Technical Bulletin

Number 192

November 5, 2010

LP Gas Valve Adjustment Screw

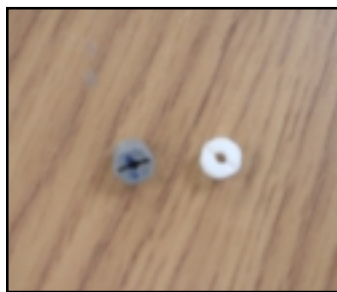
ADC has replaced the 128927 gas valve that had been used on a majority of dryers. The replacement valve comes as a natural gas valve or liquid propane valve, see conversion chart in tech bulletin number 191 dated February 16, 2010 for part numbers.

If the natural gas valve needs to be converted in the field to LP, you may need to replace the gas valve adjustment screw. Some of the natural gas valves were made with a gray colored adjustment screw that does not have the opening for the spring and pin to convert to LP (see picture). The gas valve adjustment screw with the hole is white in color and the part number is 141145. See picture for comparison of both screws. When replacing the adjustment screw, 1- remove the brass sealing cap on the top of the valve, 2- remove the gray colored adjustment screw, 3- install the new white adjustment screw with the hole. Continue according to the LP conversion instructions.
